Grahamvale BESS RFI Response Memorandum

Landscape Character and Visual Impact Assessment

Avenis Energy working on behalf of AE BESS 3

Re: Grahamvale Battery Energy Storage System (BESS) - Landscape Character and Visual Impact Assessment RFI

PM02 320 Verney Rd, Grahamvale VIC

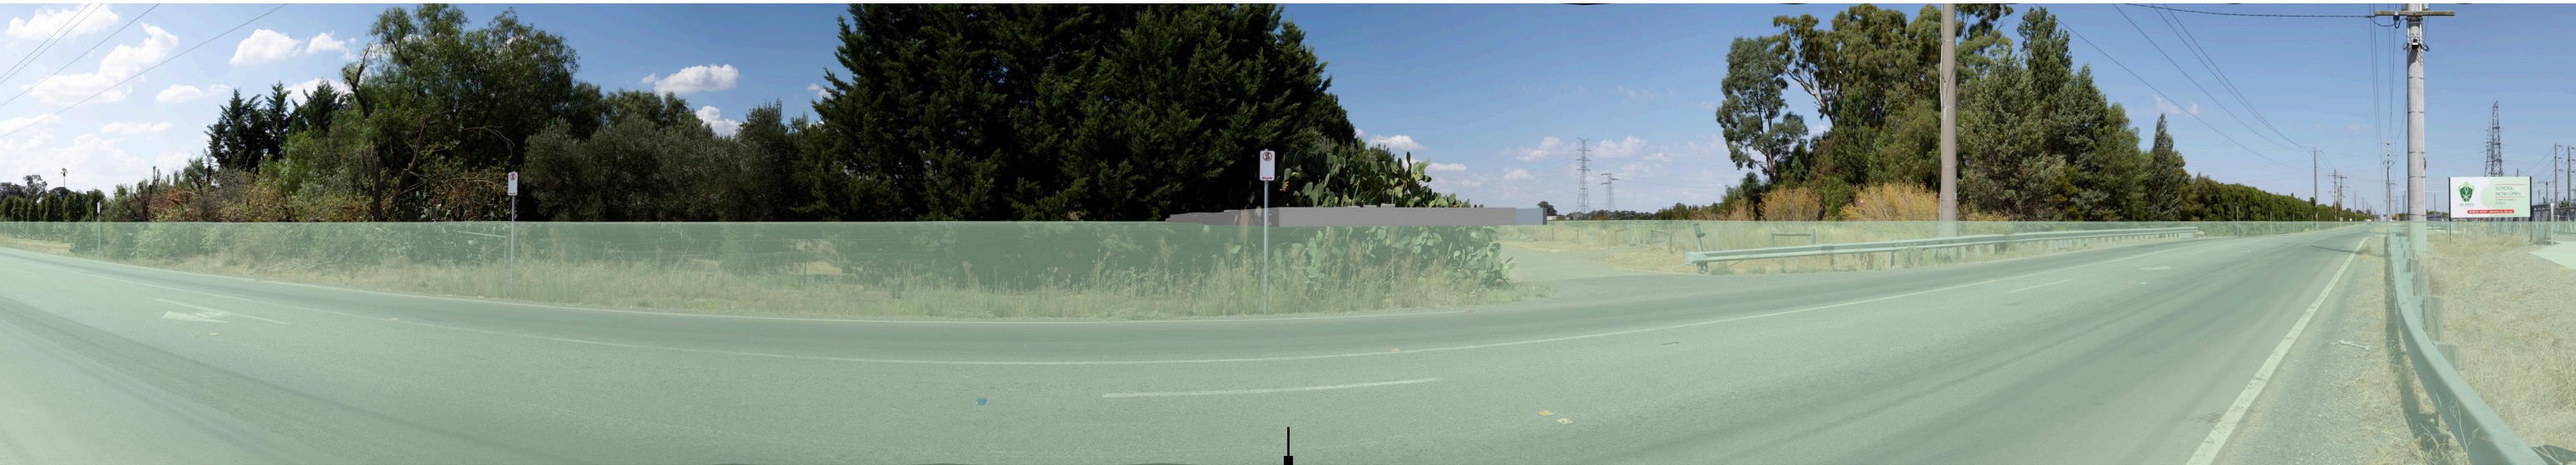
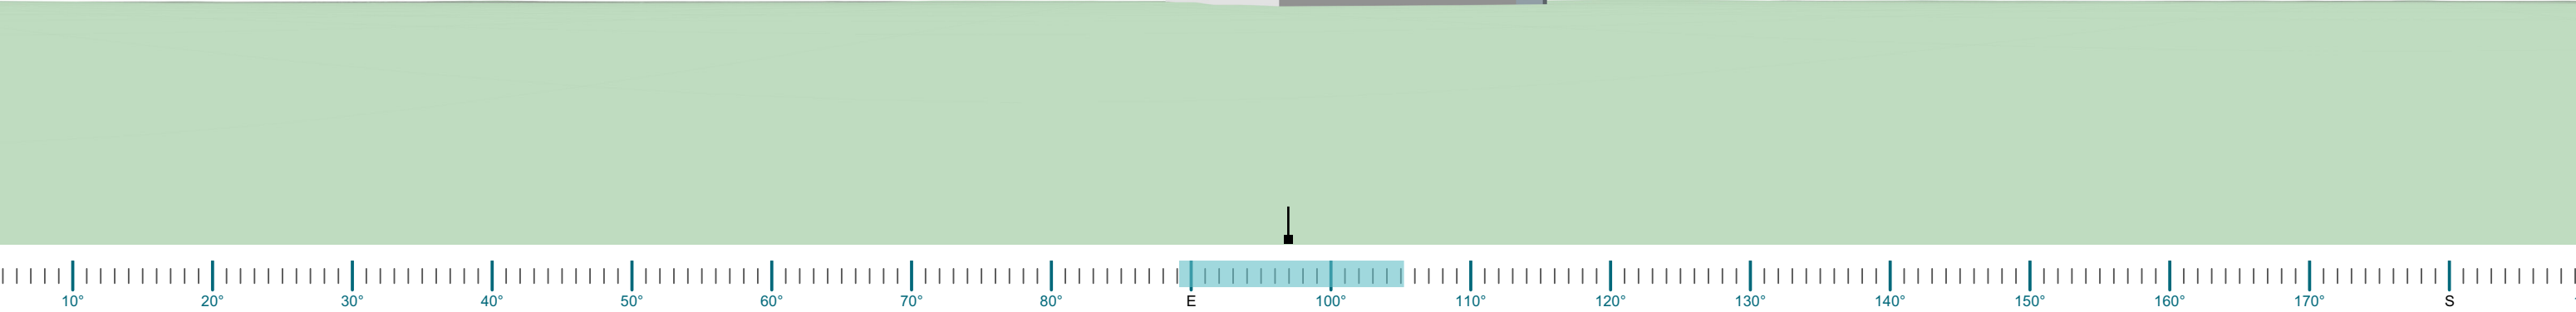
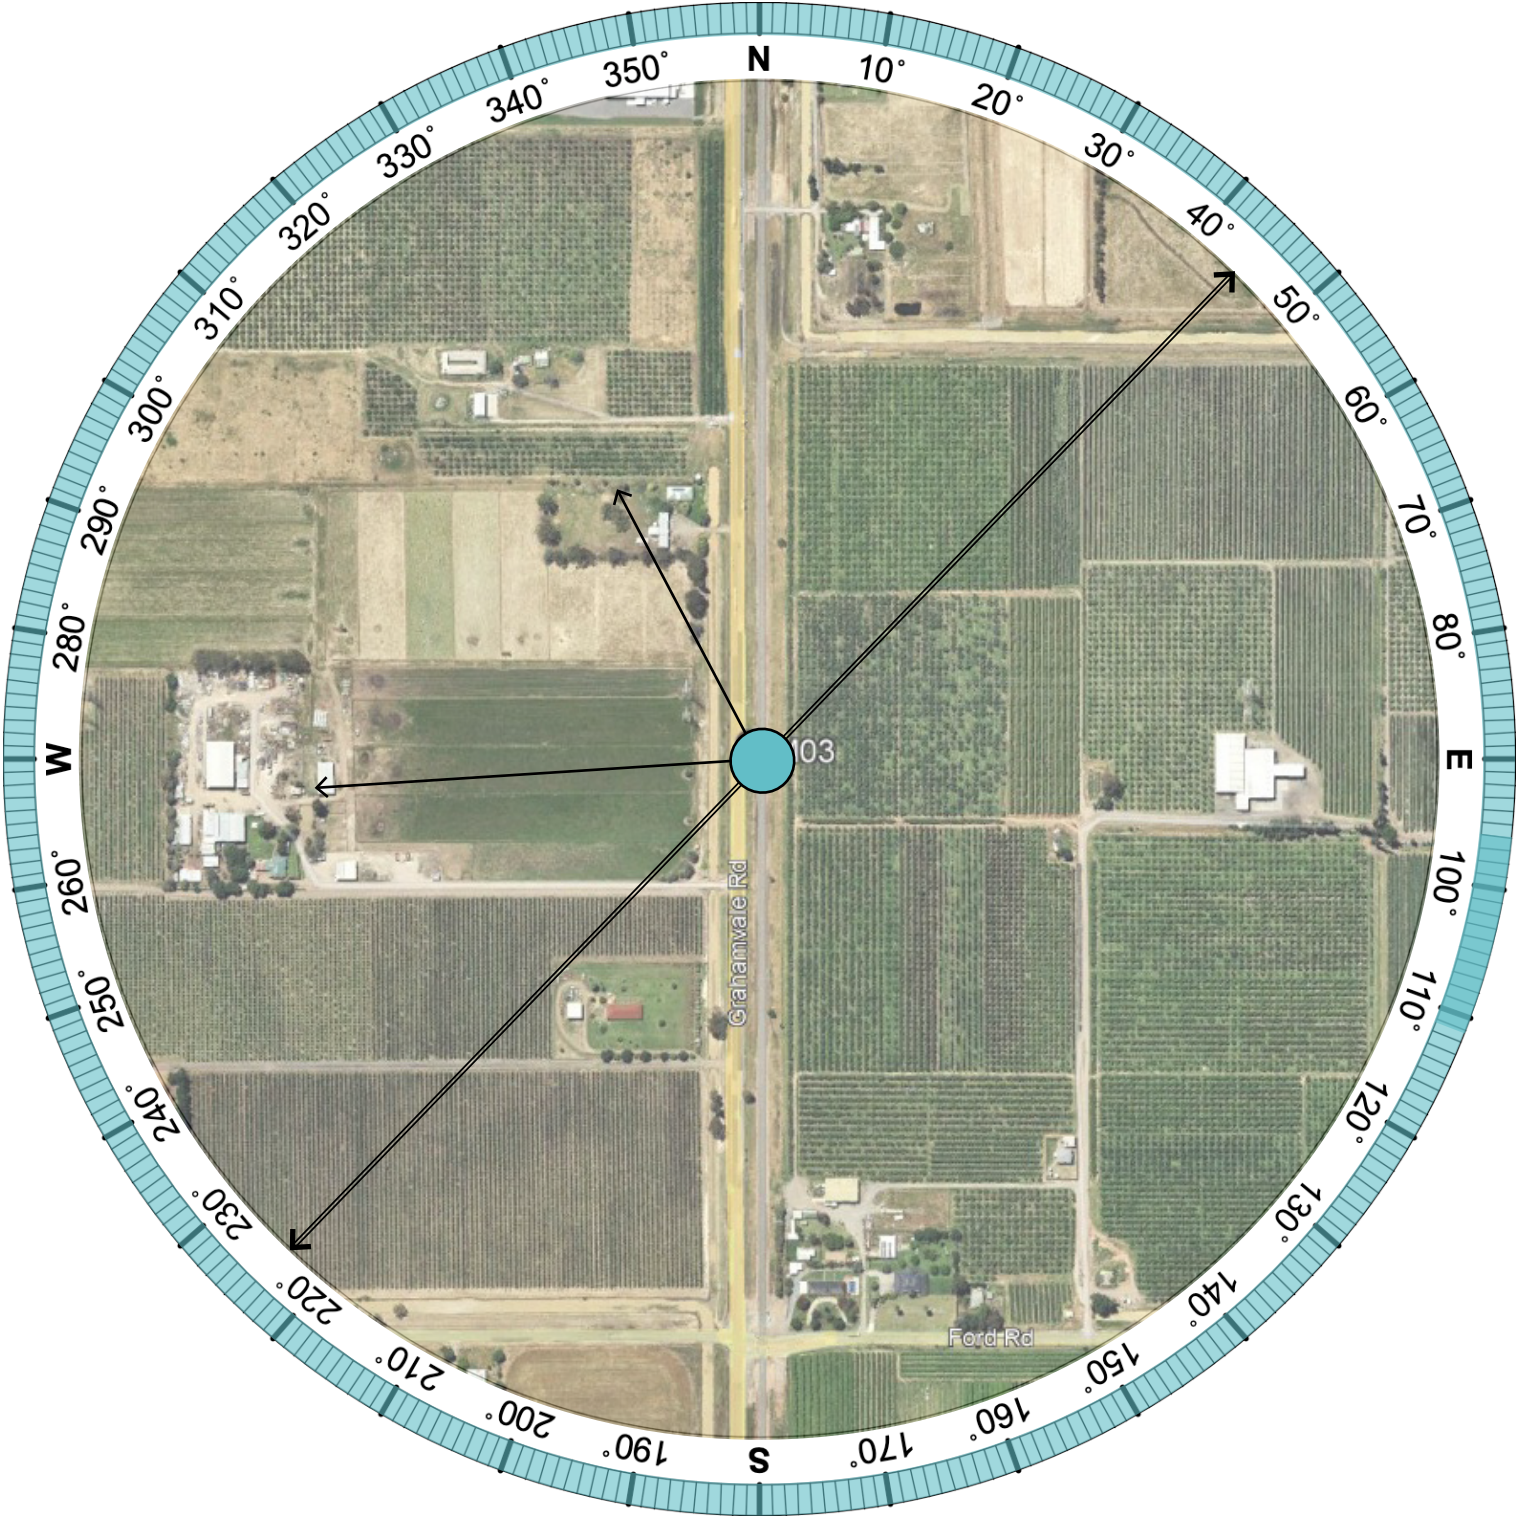
- *It is suggested that further justification for Viewpoint 3 (VP03) and Photomontage 2 (PM02) be provided in the Landscape and Visual Impact Assessment (LVIA). Viewpoint 3 (VP03) and Photomontage 2 (PM02) are taken from a location that places the development directly behind existing vegetation; however, immediately to the right / south of this location is noted in the LVIA as one which offers unobstructed views of the proposal from Verney Road. While it is considered that the LVIA is sufficient to assess impacts, it is our view that the LVIA could be more robust."*

As the DPH RFI noted 'Viewpoint 3 (VP03) and Photomontage 2 (PM02) were provided in the Landscape and Visual Impact Assessment (LVIA). Viewpoint 3 (VP03) and Photomontage 2 (PM02) are taken from a location that places the development directly behind existing vegetation; however, immediately to the right / south of this location is noted in the LVIA as one which offers unobstructed views of the proposal from Verney Road. While it is considered that the LVIA is sufficient to assess impacts, it is our view that the LVIA could be more robust.'

The vegetation mapping in **Section 3.0** demonstrates that the Project will not be visible for the majority of Verney Road, with only a small 35 m gap allowing for brief views of the Project. While VP03/PM02 was taken at this location, the narrow viewing angle created by the gap means the Project remains partially screened by vegetation at the viewpoint. However, the viewpoint and photomontage still demonstrate that the size and scale of the Project, combined with the setback of the infrastructure from the road (approximately 200 m at its closest point), results in a low visual magnitude (refer to the wireframe and wireframe overlay included in PM02). Additionally, while gaps in vegetation may allow partial views of the BESS infrastructure from short sections of Verney Road (refer to **Image 07** & **Image 08**), viewer sensitivity is considered low due to the brief and transient nature of views experienced by road users, leading to an overall low visual impact rating.
